# Access Compliance Report

## Public Rights-of-Way

### (Curb Ramps)

Intersection ID: 48570	Main Street: MATLEA_CT	Cross Street: RED_SQUIRREL_TL	Location: W
ADA ID: FDA36B94235B	Ramp Type: PerpDiag	Initial Pass/Fail: Pass	Overall Compliance: No
Severity Score: 0			
Codes/Mitigation Info/Possible Solution		Field Measurements/Component Compliance

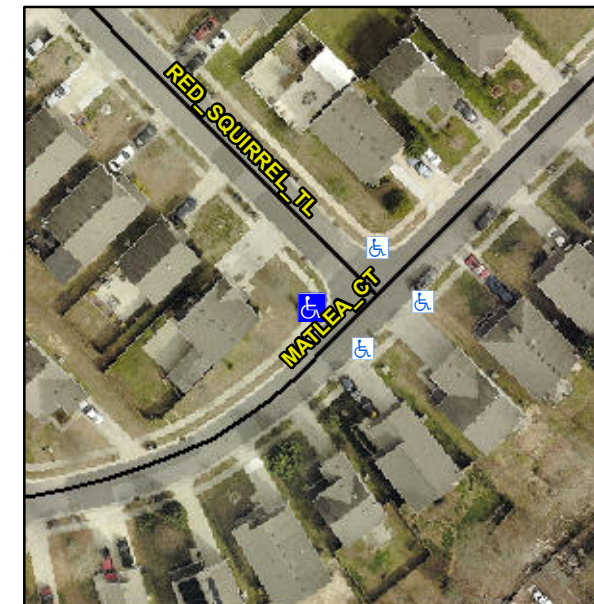
**Not Found, R304.2.1, R304.5.3**

Compliance	Description	Data	Compliance	Description	Data
N/A	Ramp Length (in)	48.0	Yes	Ramp Slope (%)	6.2
Yes	Ramp Width (in)	48.0	Yes	Ramp XSlope (%)	0.6
N/A	Flare Type LT	Sloped	N/A	Flare Type RT	N/A
N/A	Flare Slope LT (%)	0.3	N/A	Flare Slope RT (%)	4.1
N/A	Flare Traversable LT?	No	N/A	Flare Traversable RT?	No
No	Landing Length (in)	46.0	Yes	DWS Provided?	Yes
Yes	Landing Width (in)	67.5	Yes	DWS Contrast?	Yes
Yes	Landing Slope (%)	0.9	Yes	DWS Length (in)	24.0
Yes	Landing X Slope (%)	1.6	Yes	DWS Full Width?	Yes
N/A	Landing Curb? (Y/N)	No	Yes	DWS Offset (in)	1.0
N/A	Shared Landing?	No			
Yes	Gutter Ponding?	No	Yes	Gutter Slope (%)	1.0
Yes	Gutter Lip Ht (in)	0.0	No	Gutter X Slope (%)	2.5
N/A	Painted X Walk1?	No	N/A	Painted X Walk2?	No
	X Walk 1 Direction	To SE		X Walk 2 Direction	To NE
N/A	X Walk 1 Width (in)	N/A	N/A	X Walk 2 Width (in)	N/A
	X Walk 1 Slope (%)	3.0		X Walk 2 Slope (%)	1.3
	X Walk 1 X Slope (%)	2.6		X Walk 2 X Slope (%)	1.4

**Remove & Replace Curb Ramp With Two New Directional Ramps or Equivalent. Remove & Replace Gutter.**
